ADDENDUM NO. 4

January 30, 2023

Three Rivers Community Schools – Three Rivers Middle School Additions and Renovation

This Addendum consists of Pages ADD 4-1 through ADD 4 - 3, Attached RFI Log, Substitution Request, and GMB Architecture and Engineering Addendum No. 4, dated January 26, 2023, consisting of 4 pages, Reissued Specification Sections; 08 71 00 – Door Hardware, 09 22 16 – Non-Structural Metal Framing, and 09 65 19 - Resilient Tile Flooring, New Sheet; S3.1E, and Reissued Sheets; G0.00, G1.01, G2.01, C8.01, A1.1E, A2.1E, A2.30, A5.01, A6.01, A7.03, A8.01, A8.02, M1.1D, M1.1E, M1.81, M2.1C, M2.1D, M2.1E, M3.1D, M8.01, M8.03, M8.04, M9.01, M9.02, E1.1C, E1.1D, E2.1D, E2.1E, and E7.01.

G1.01CODE COMPLIANCE PLAN

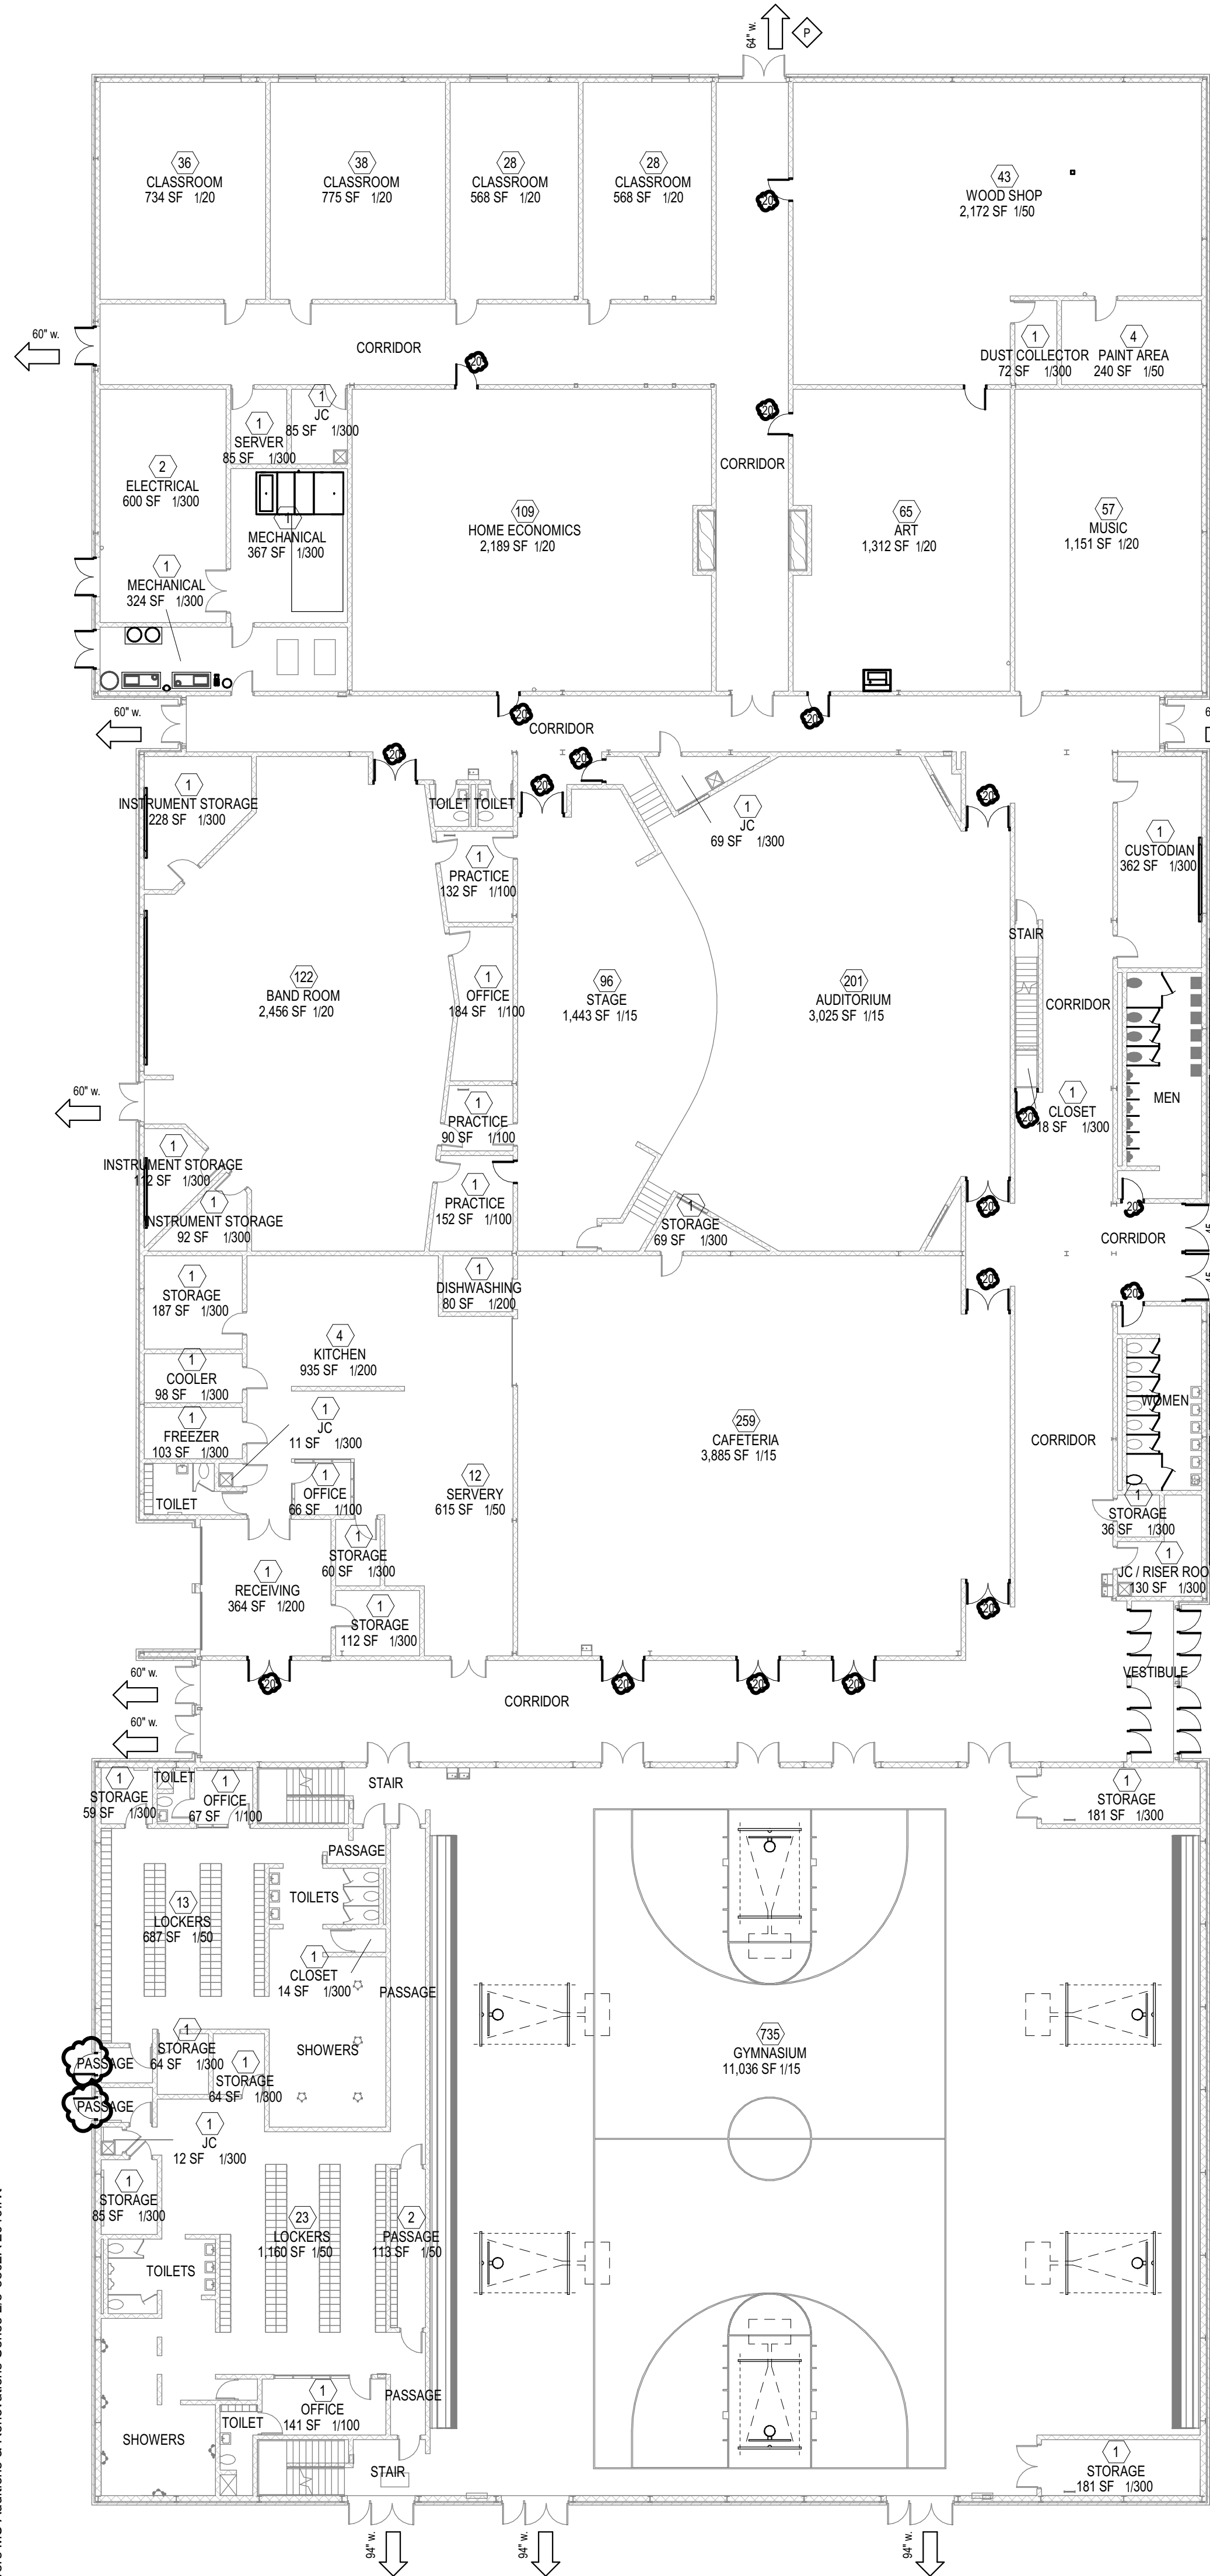
- A. Added door ratings in Units C, D, and E.
- B. Added new doors E134A and E141A.
- C. Added reference to 2015 Michigan Rehabilitation Code to plan.

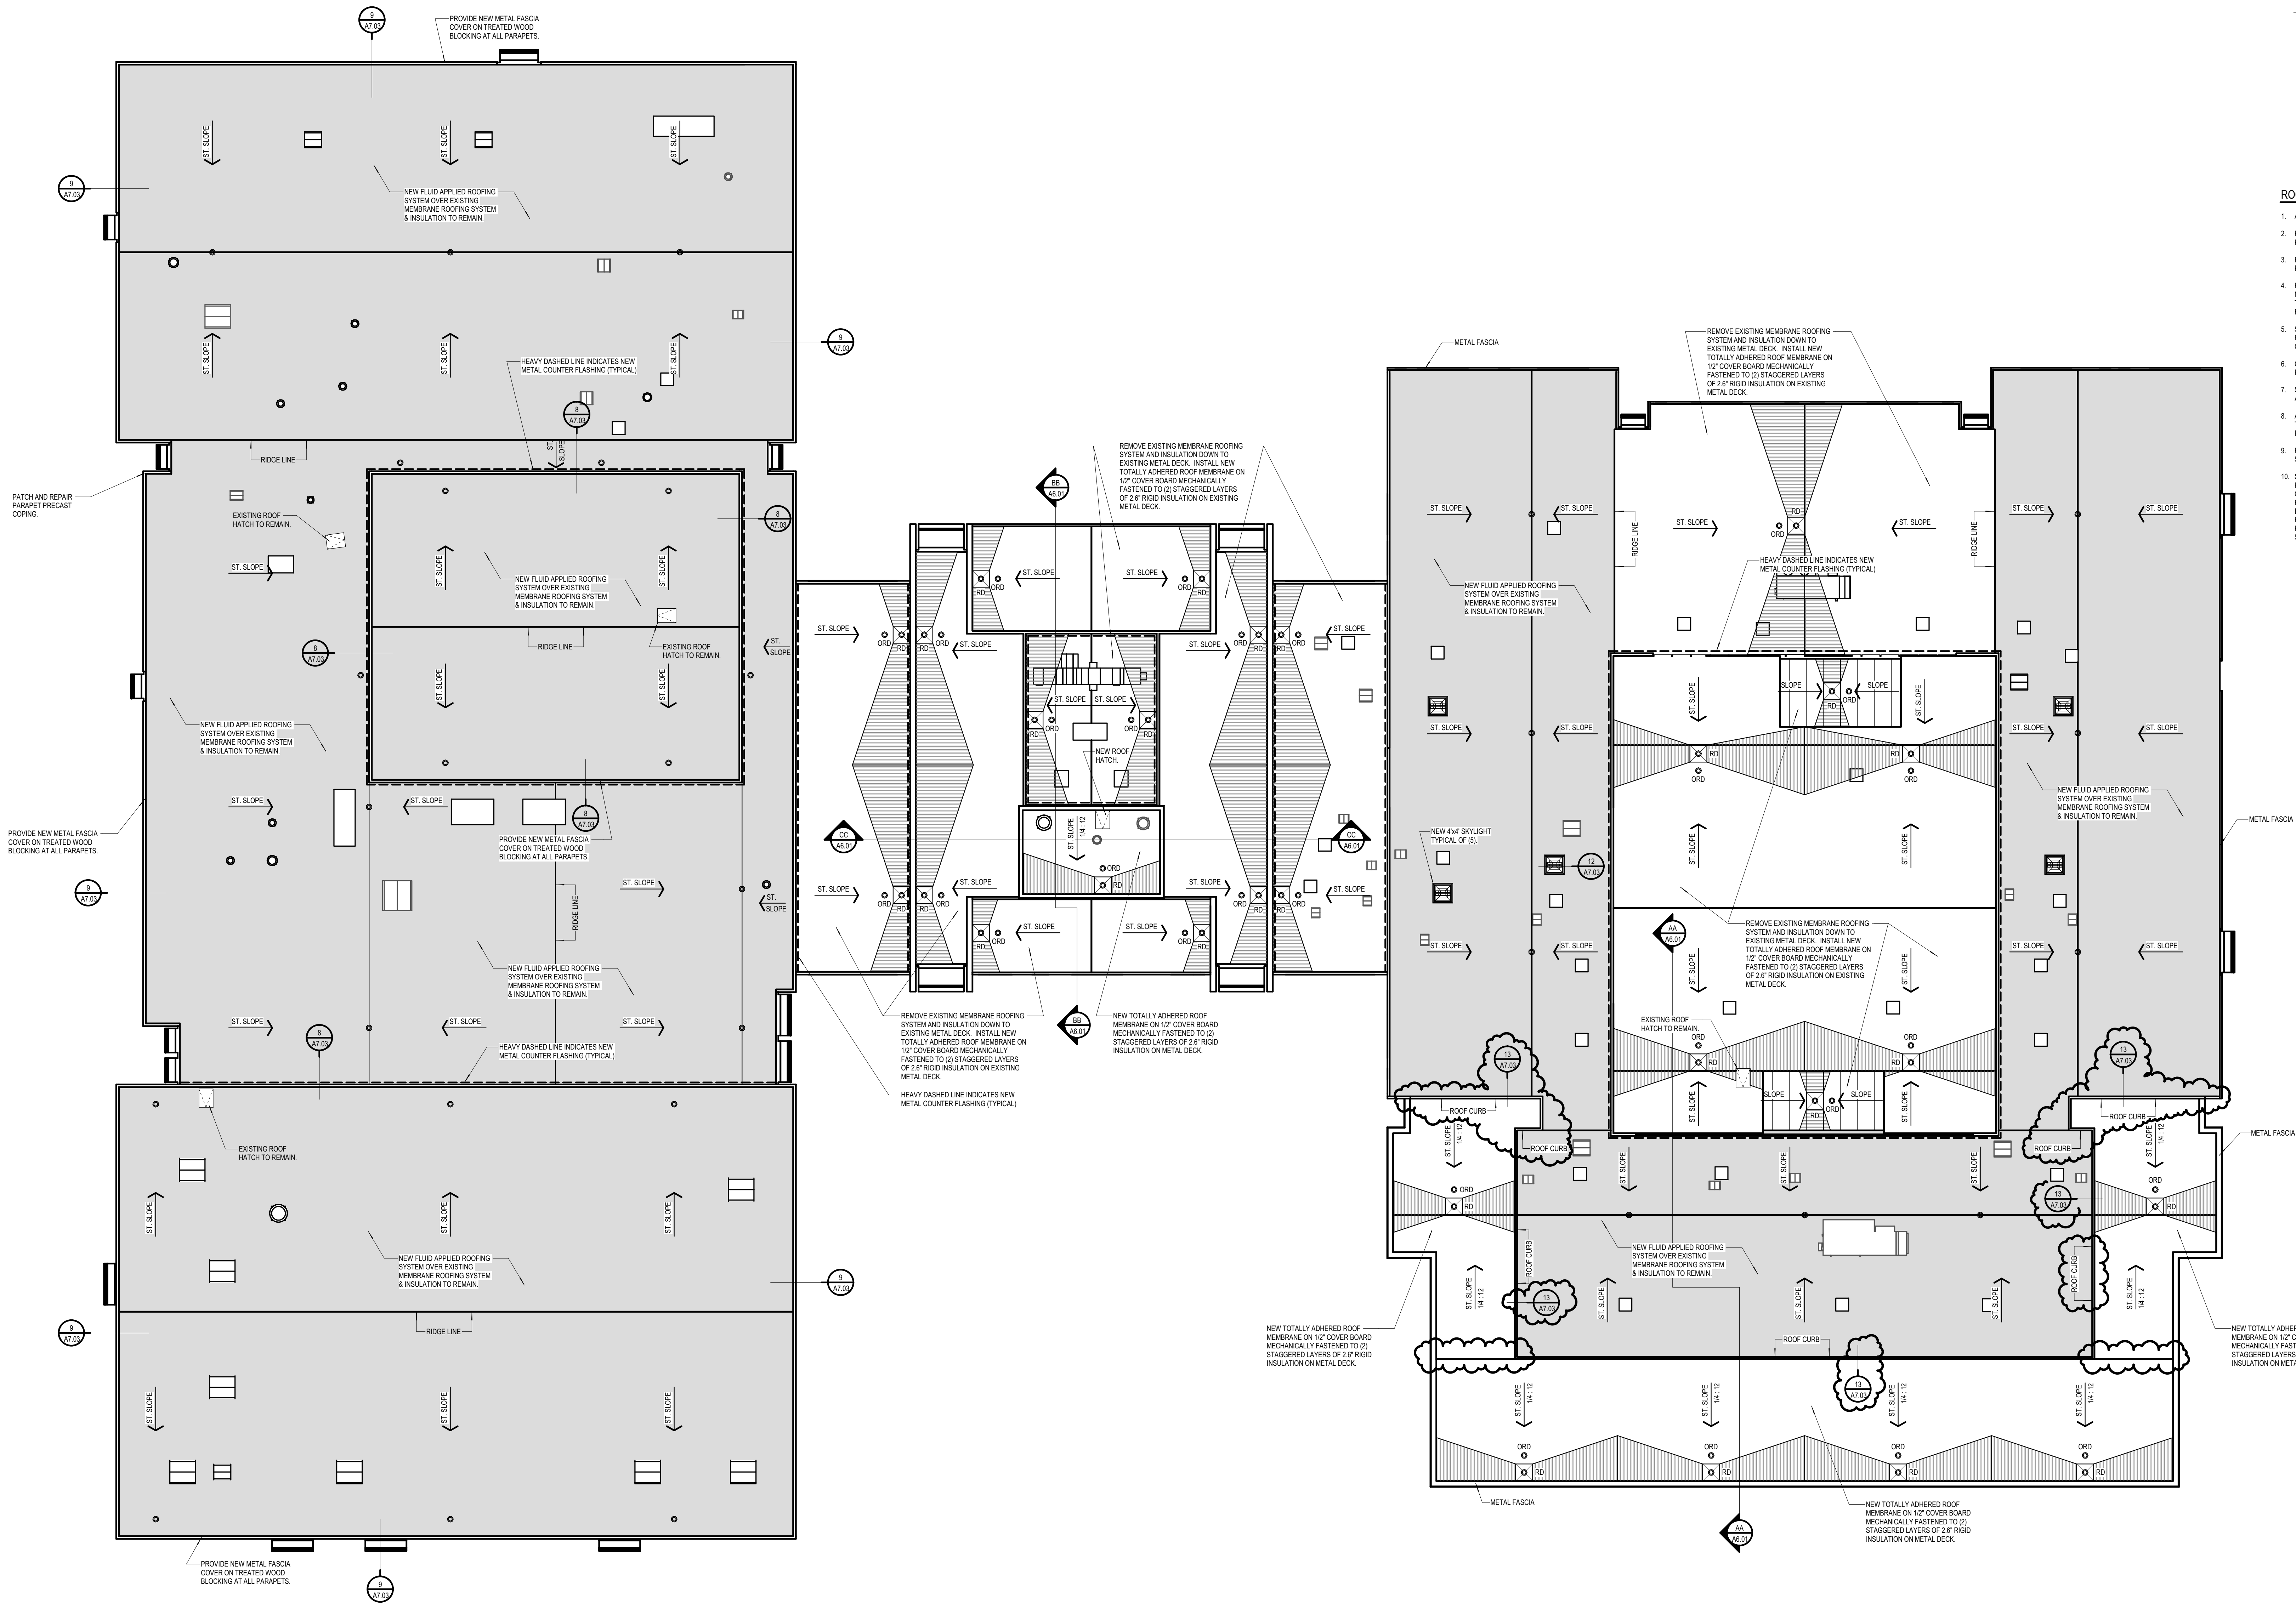
Clarified roof curb detail and locations at addition.

9 TOP OF WALL FLASHING DETAIL
1" = 1'-0"

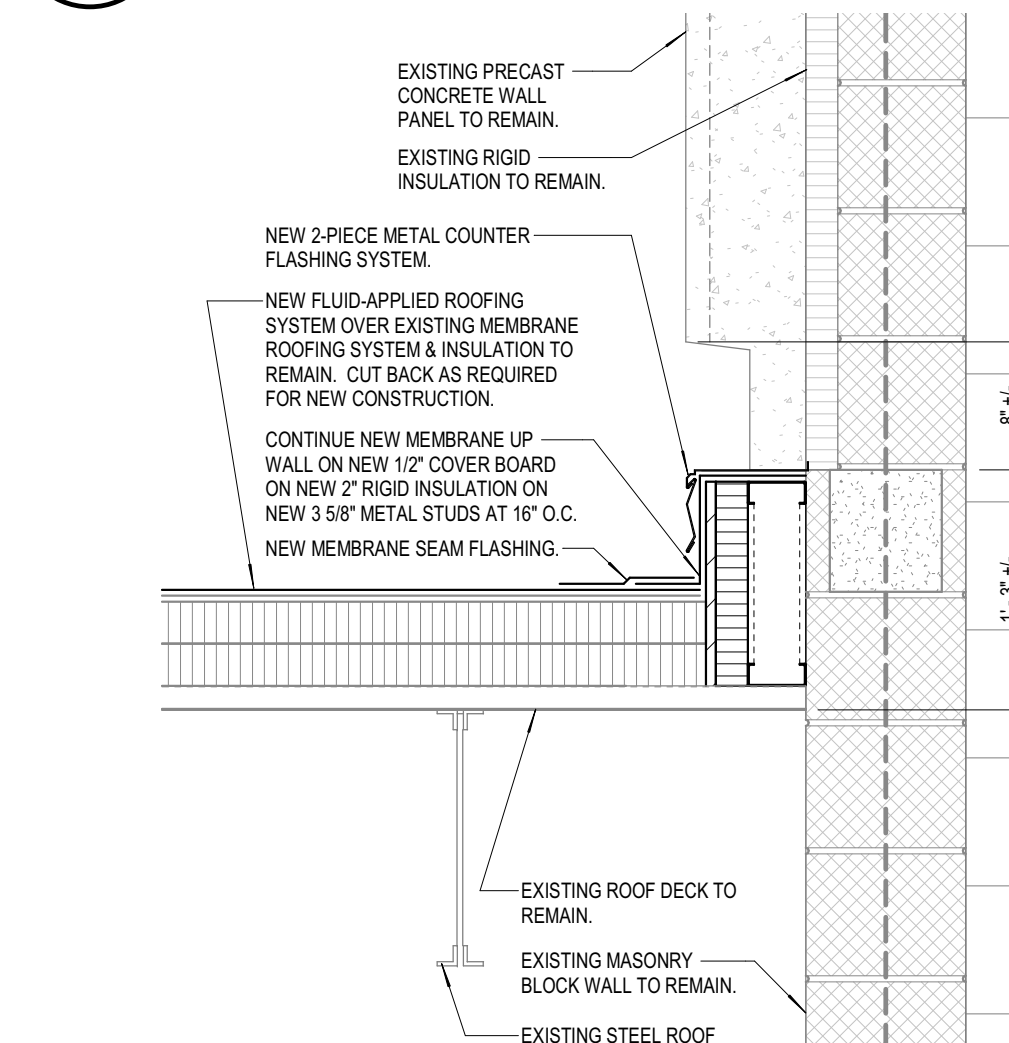
2. **Bid Category No. 12 Painting** is to provide paint at underside of wood nailer at all flutes in wall panel, as detailed on 9/A7.03.

13 ROOF CURB DETAIL
1 1/2" = 1'-0"

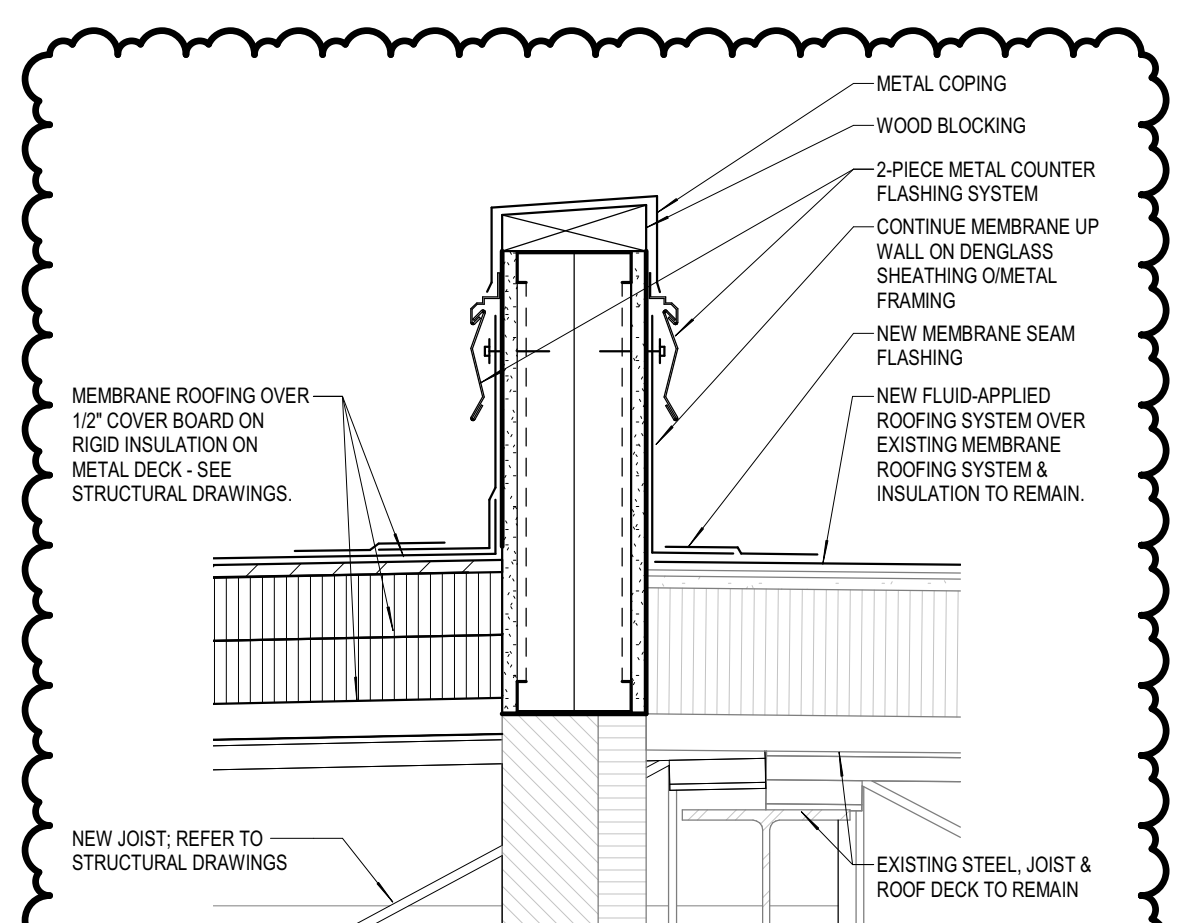
6. **Bid Category No. 9 Metal Stud, Gypsum Board, and Acoustical Ceiling** is to provide parapet wall framing and sheathing as detailed in section 13/A7.03.
7. **Bid Category No. 7 General Trades** is to provide all wood blocking as detailed. This includes but is not limited to top of wall conditions; Window Louver and Door Jambs, Louver and Windowsills, and Door Headers.
8. **Bid Category No. 12 Painting** is to provide paint at underside of wood nailer at all flutes in wall panel as detailed on 9/A7.03.

4. **Bid Category No. 9 Metal Stud, Gypsum Board, and Acoustical Ceiling** is to provide parapet wall framing and sheathing as detailed in section 13/A7.03.
5. Gypsum board ceiling in Media Center/Learning Commons Room A111 is to

Added Detail 13/A7.03 for transition between new and existing roof.

Added Detail 13/A7.03 for transition between new and existing roof.
